To: Cumberland Planning Board
From: Carla Nixon, Town Planner
Date: May 14, 2019
Subject: Amendment to Major Site Plan - Friends School - Route 1

**RE: Response to Town Comments
Major Site Plan Amendment
Friends School, 11 US Route One
Cumberland, Maine**

POST-DEVELOPMENT
DRAINAGE
ANALYSIS PLAN
D2.0

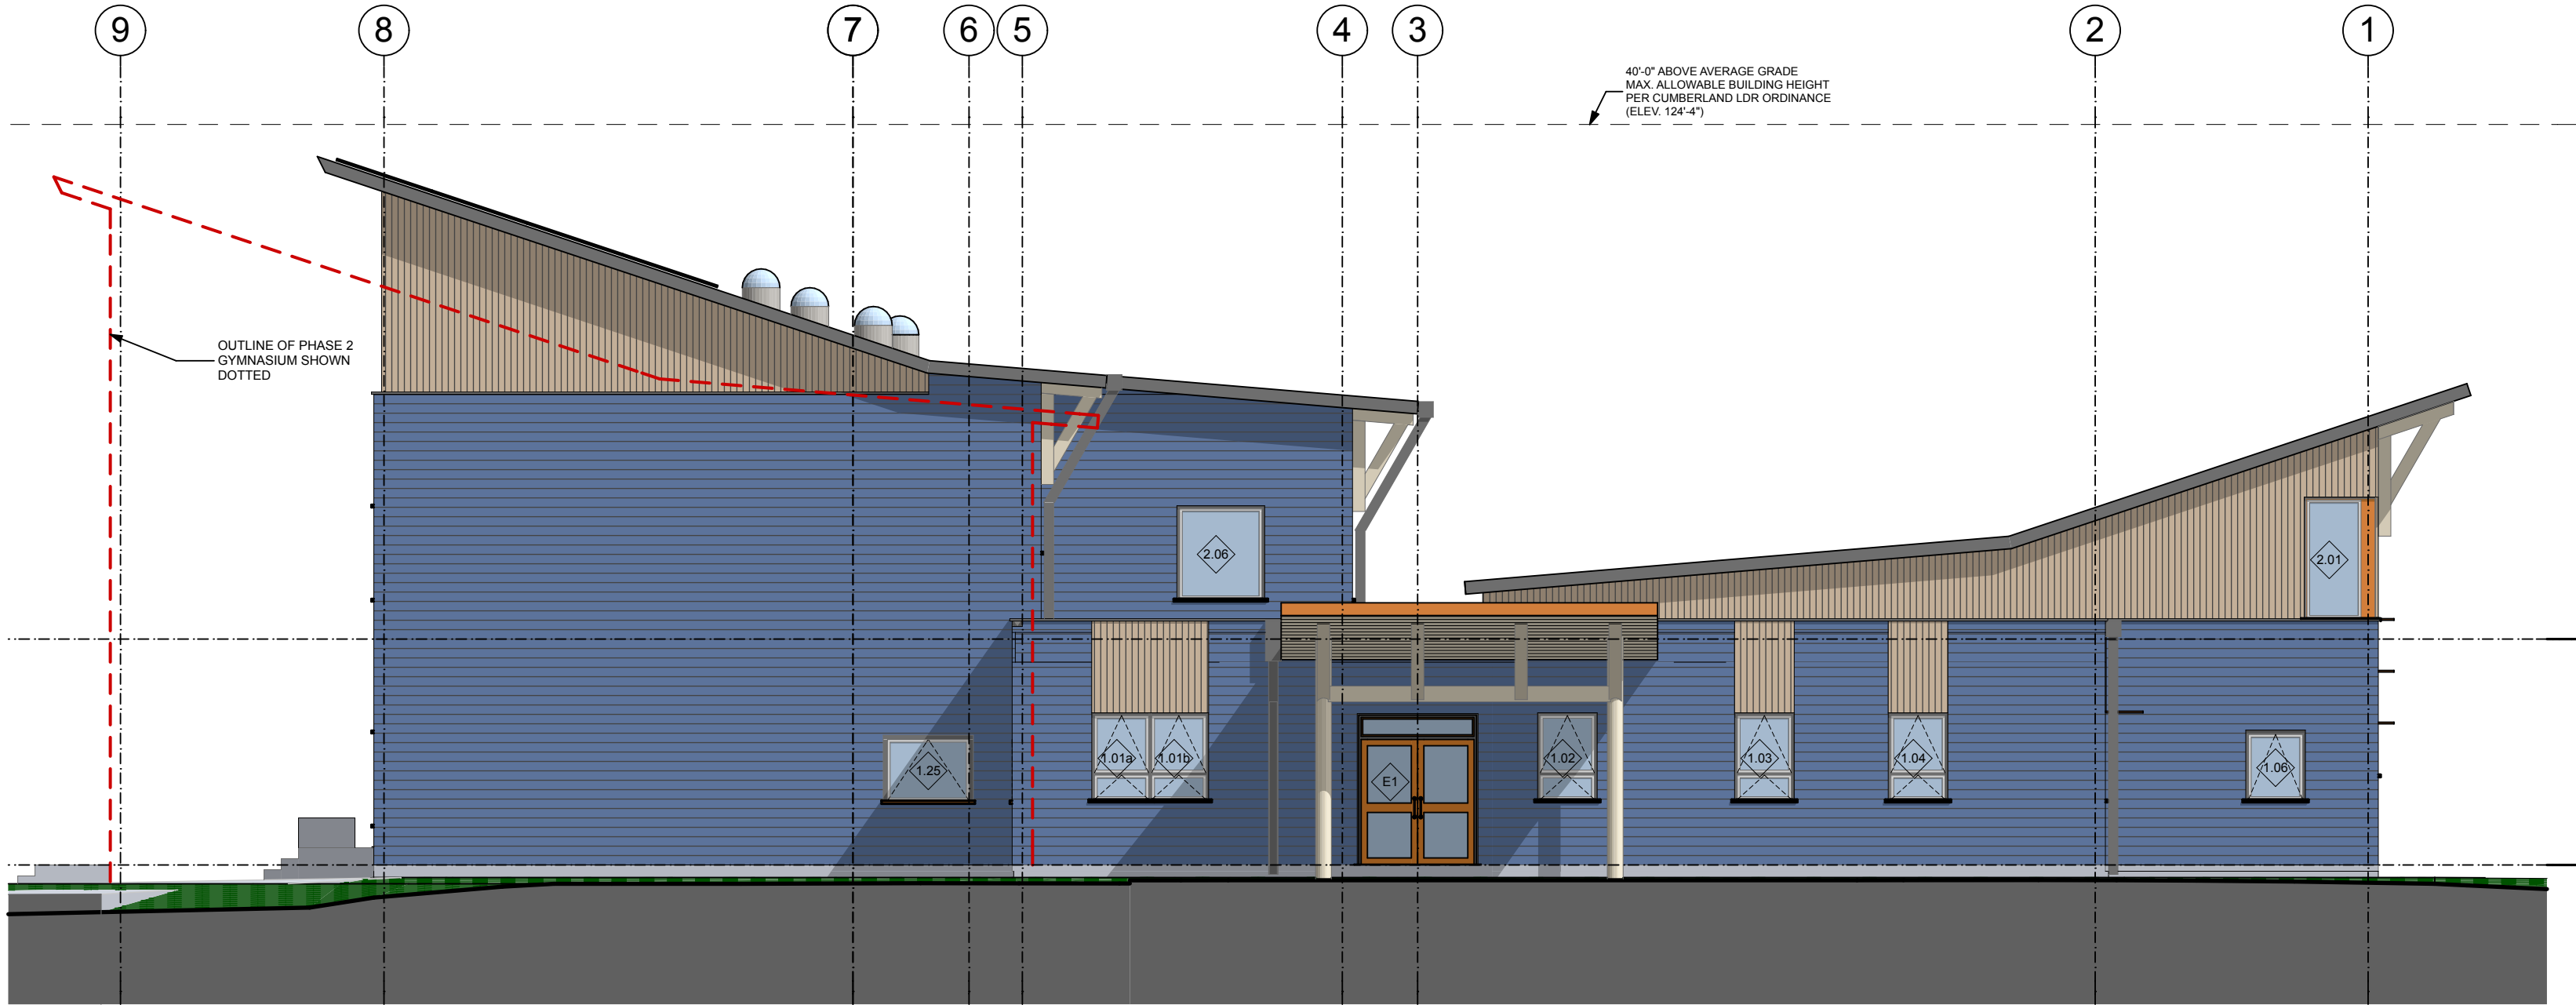
3. Please revise the Post Development Drainage Plan, D2.0 with the proposed pavement, storm drainage, and grading.

The plan has been revised accordingly.

Exhibit 8
Architectural Elevations

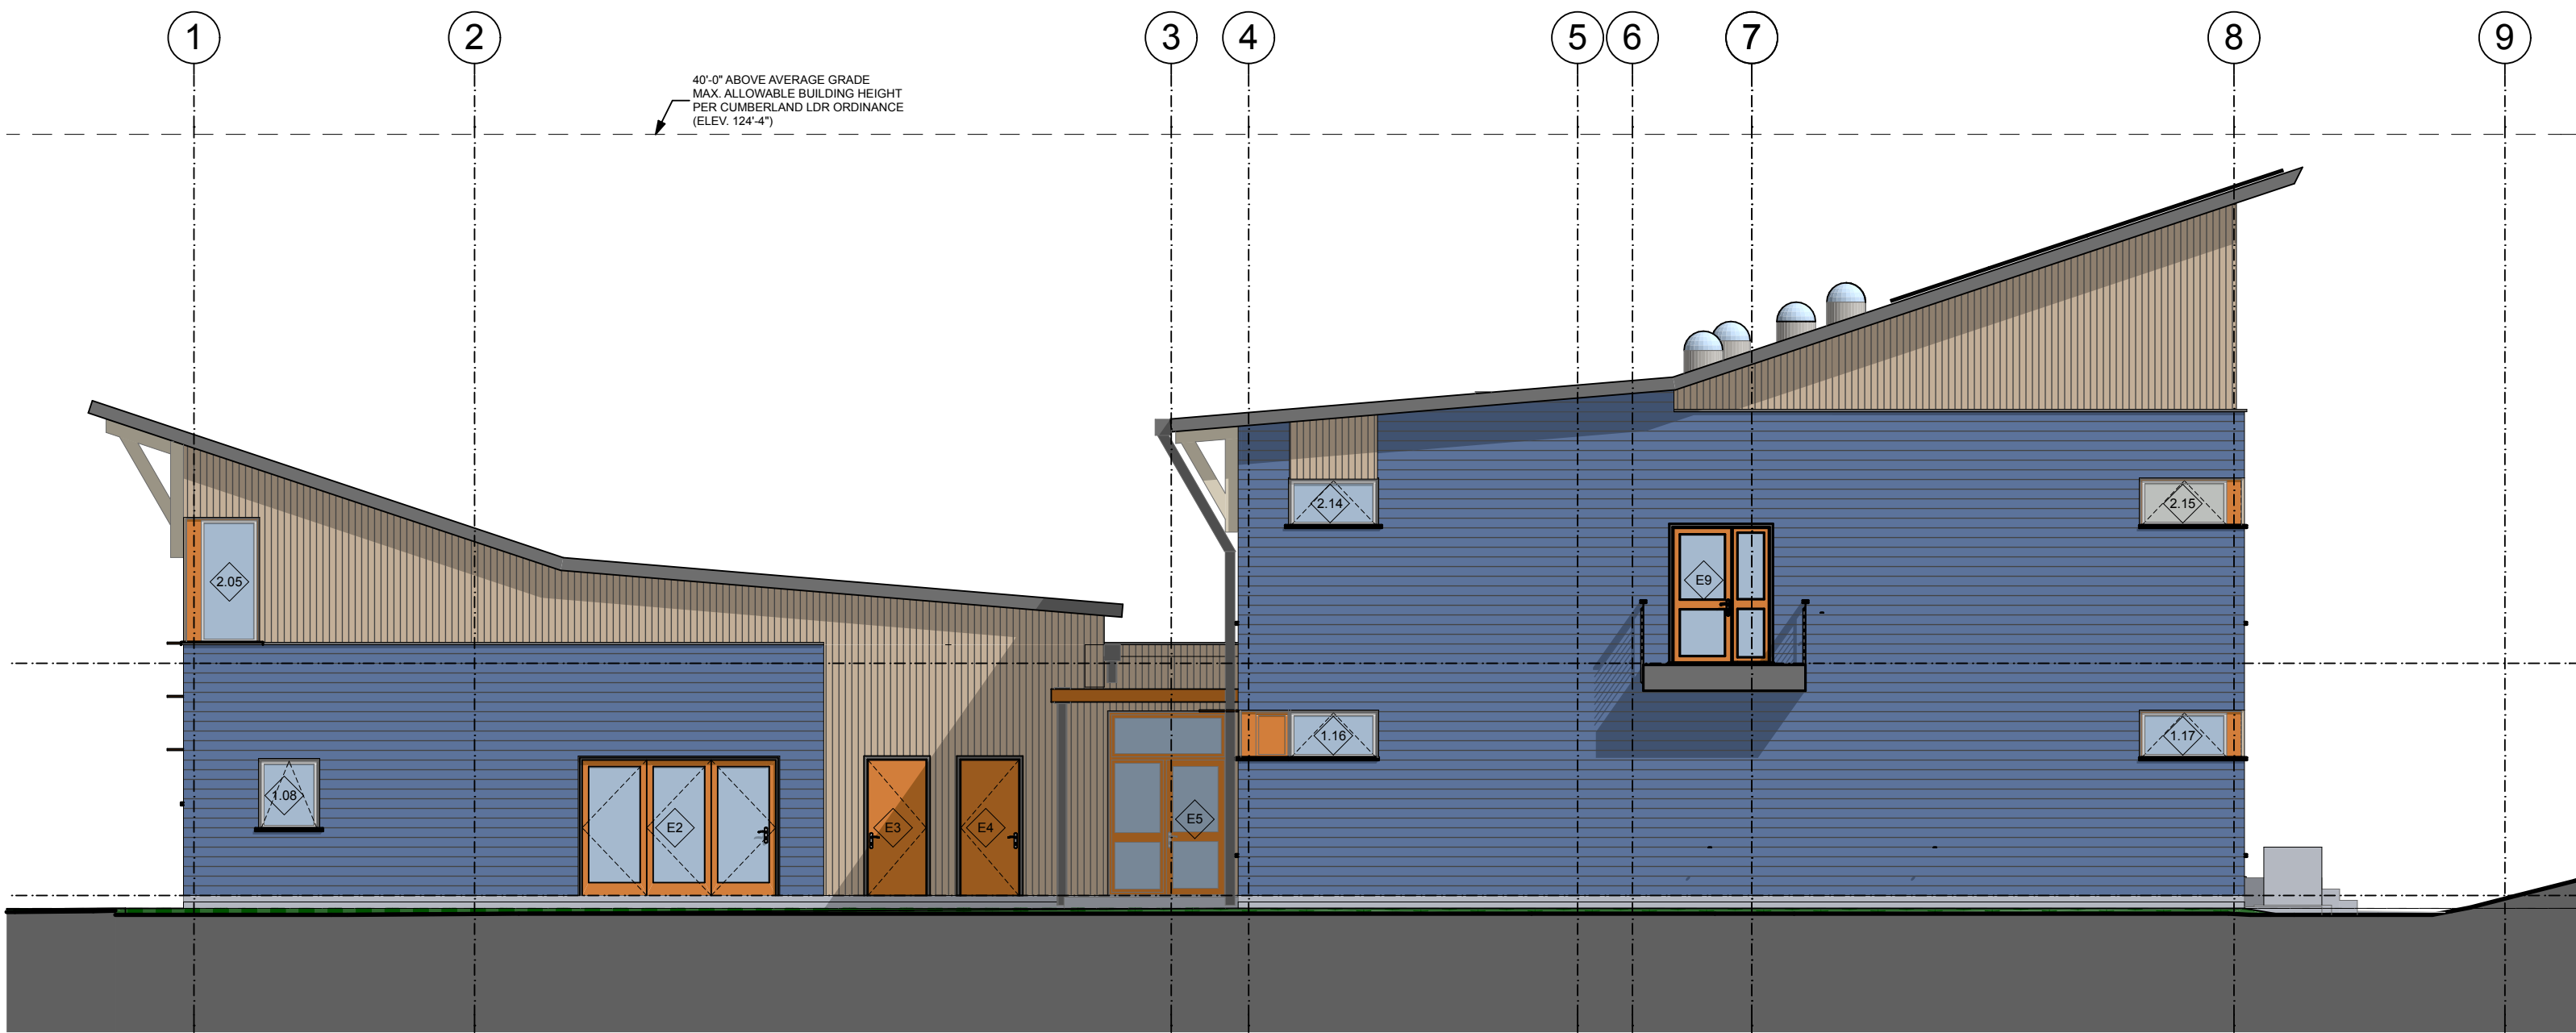
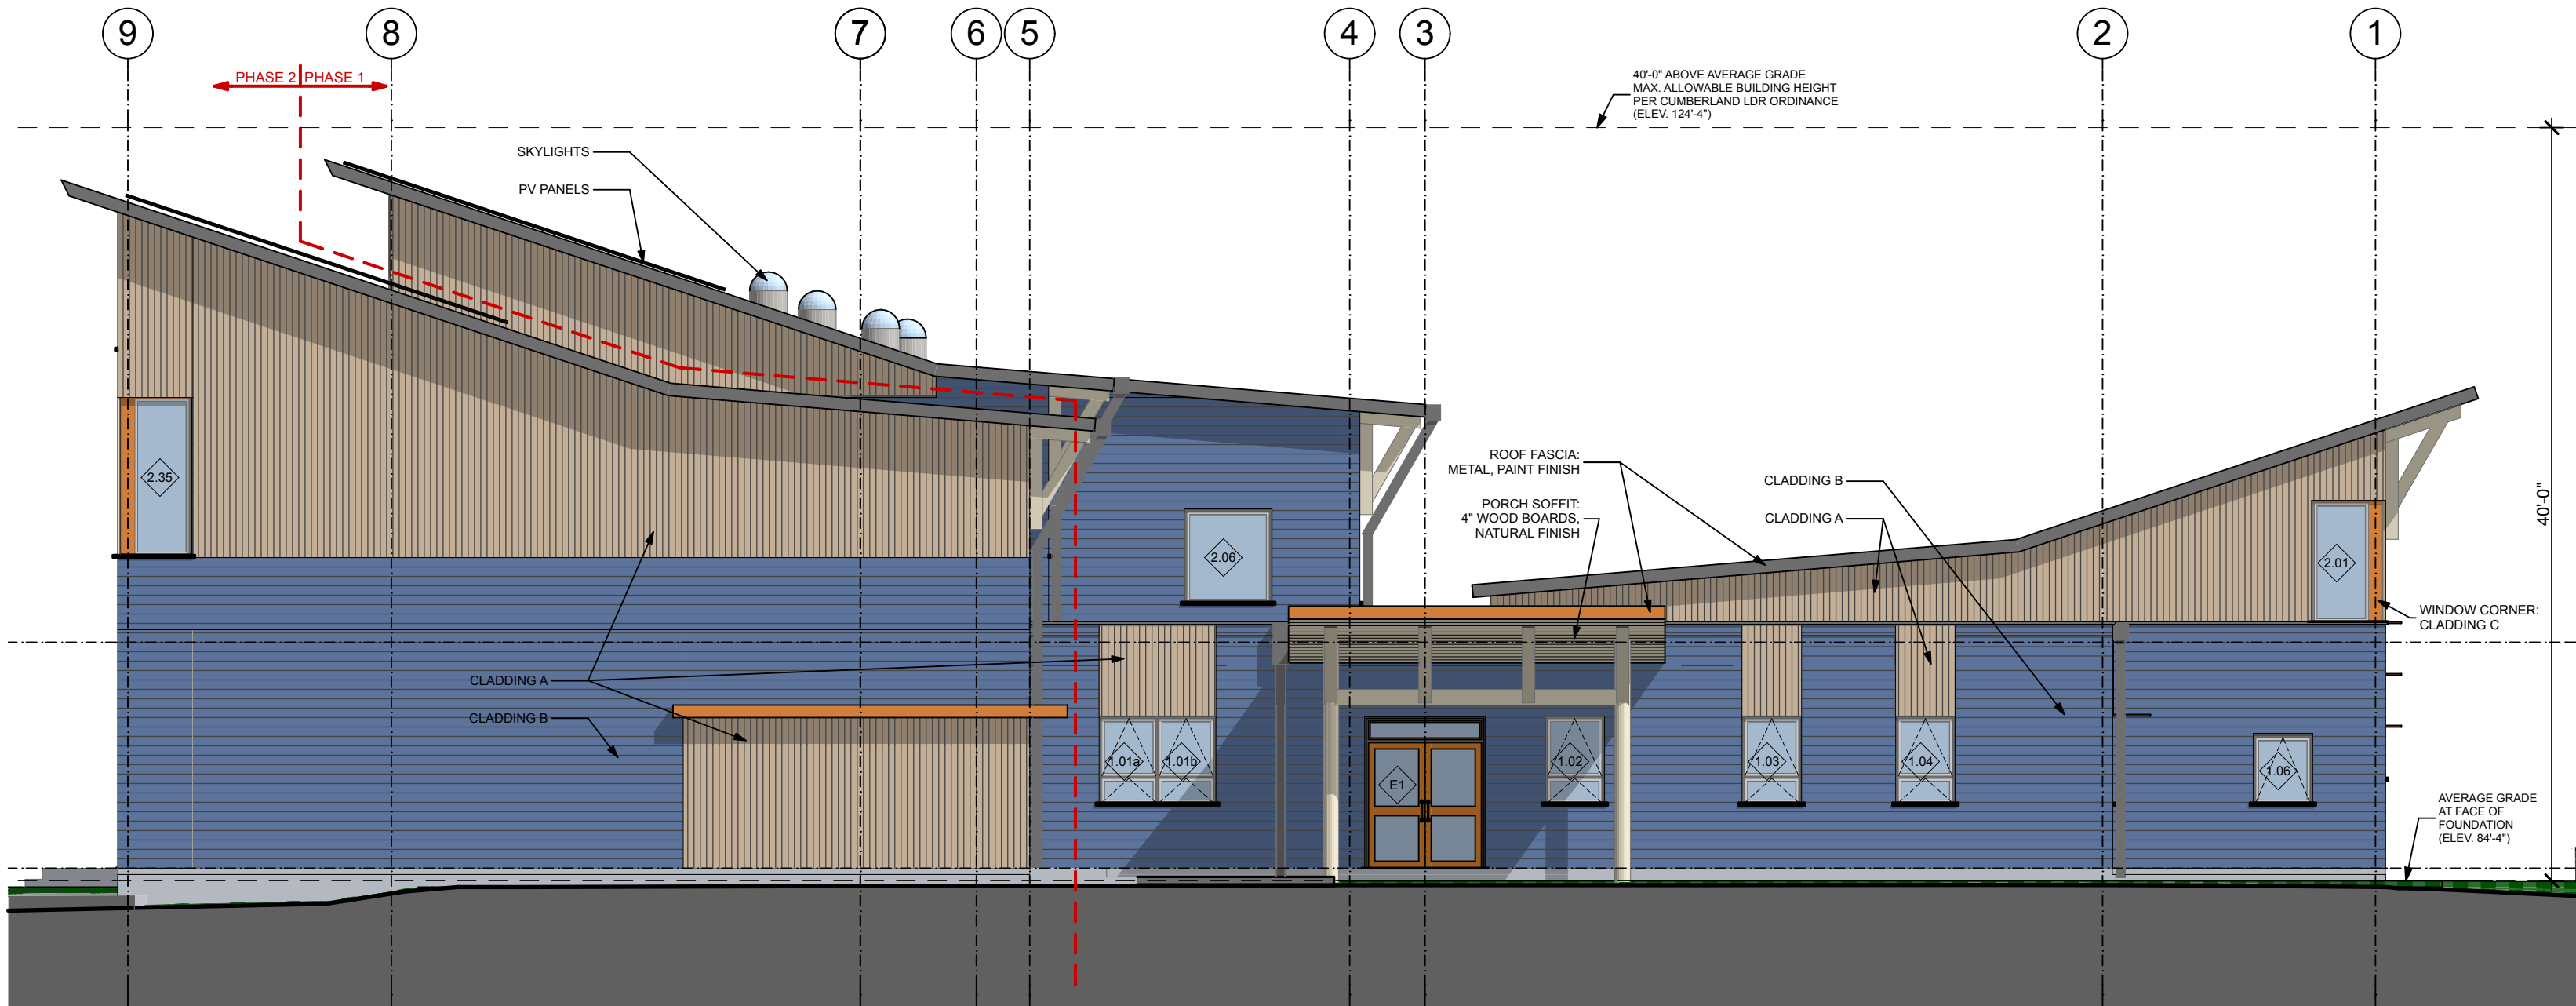
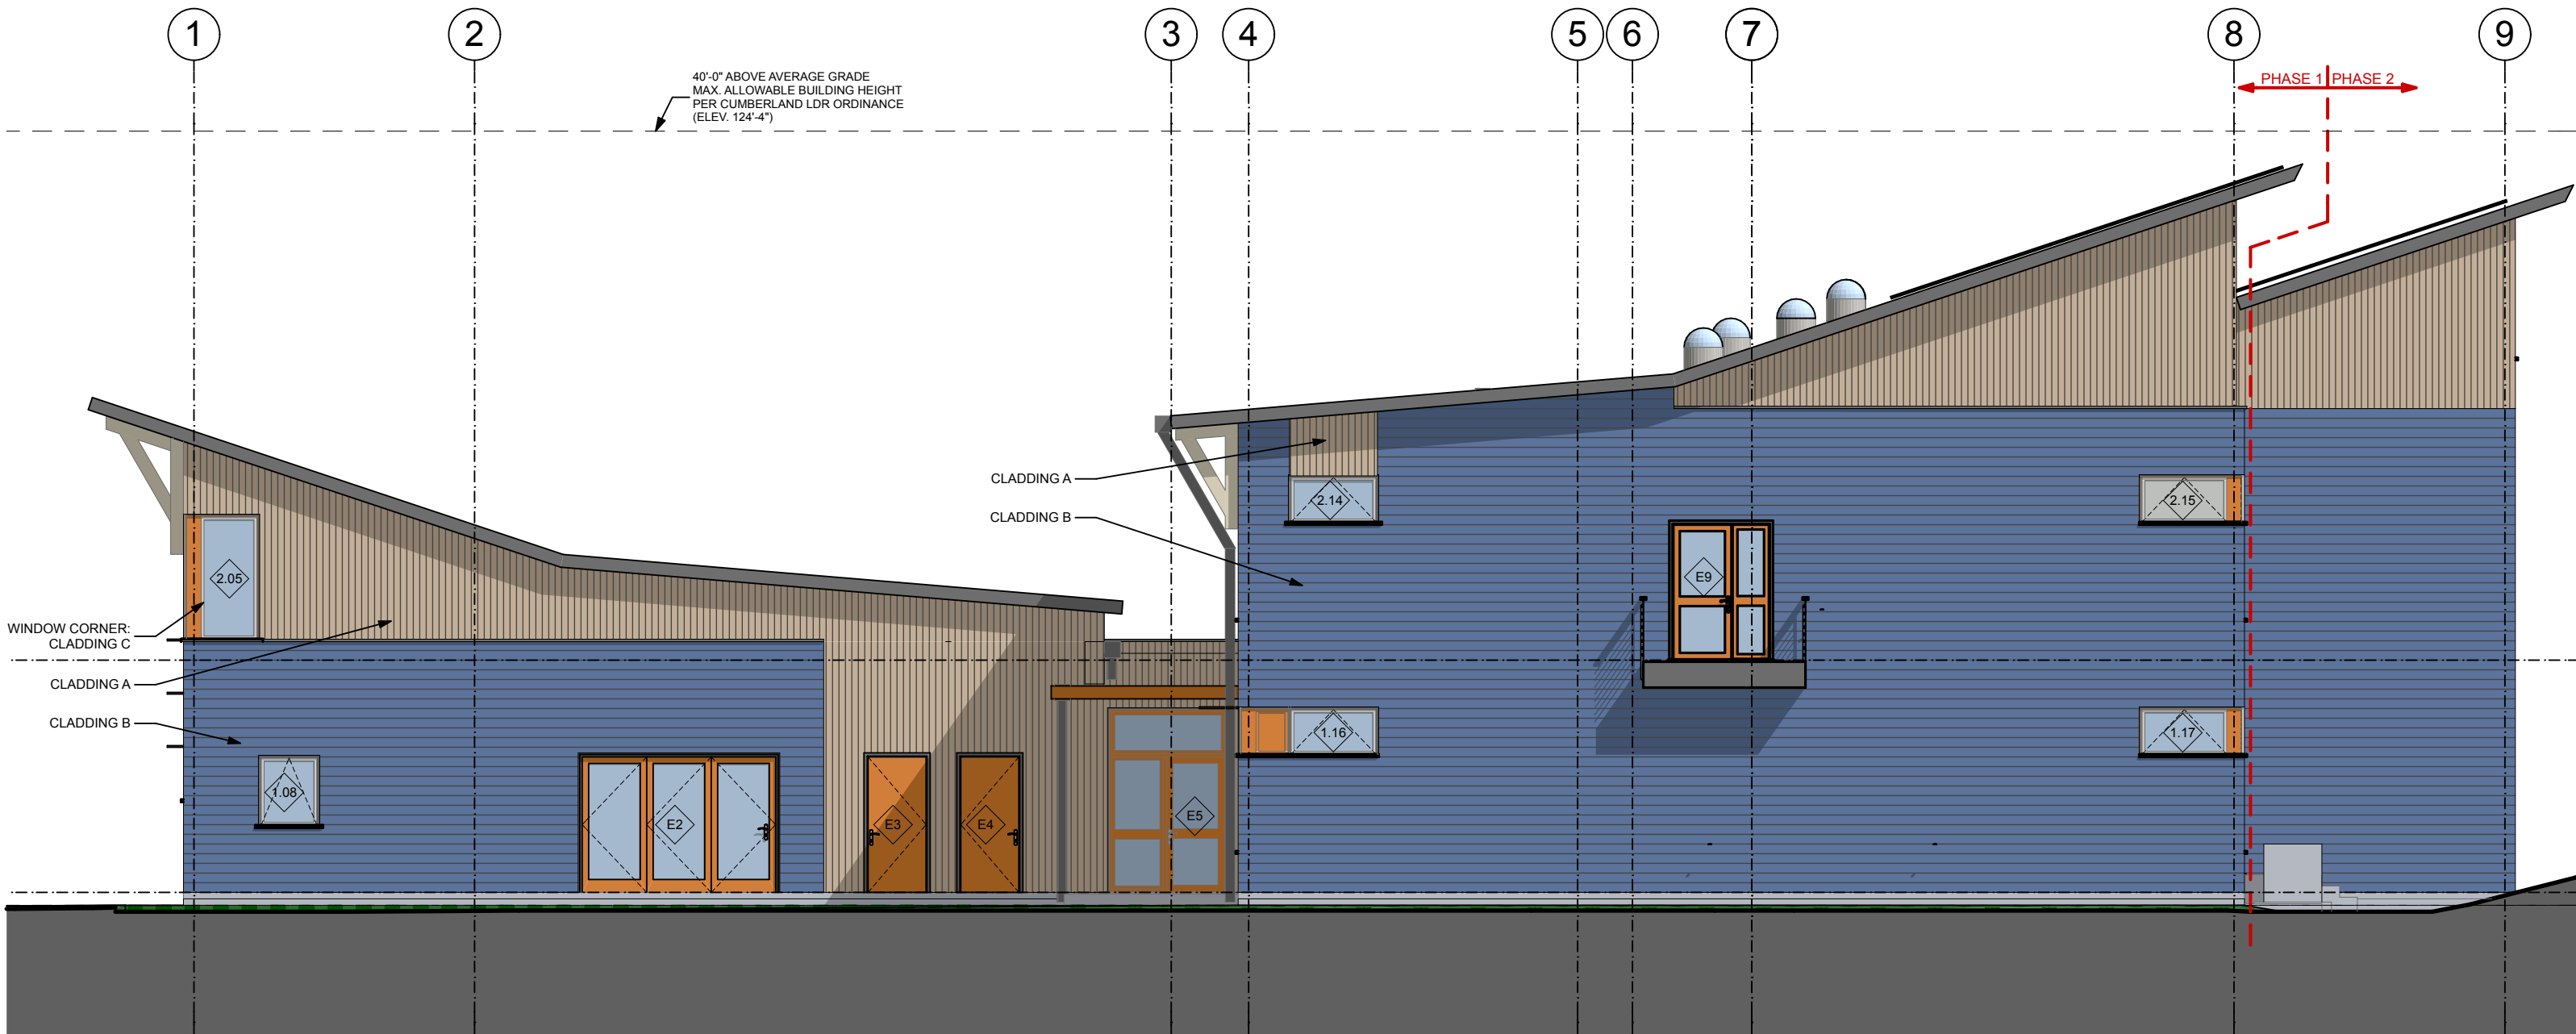
3. Please provide elevation drawings for the three sides of the addition.
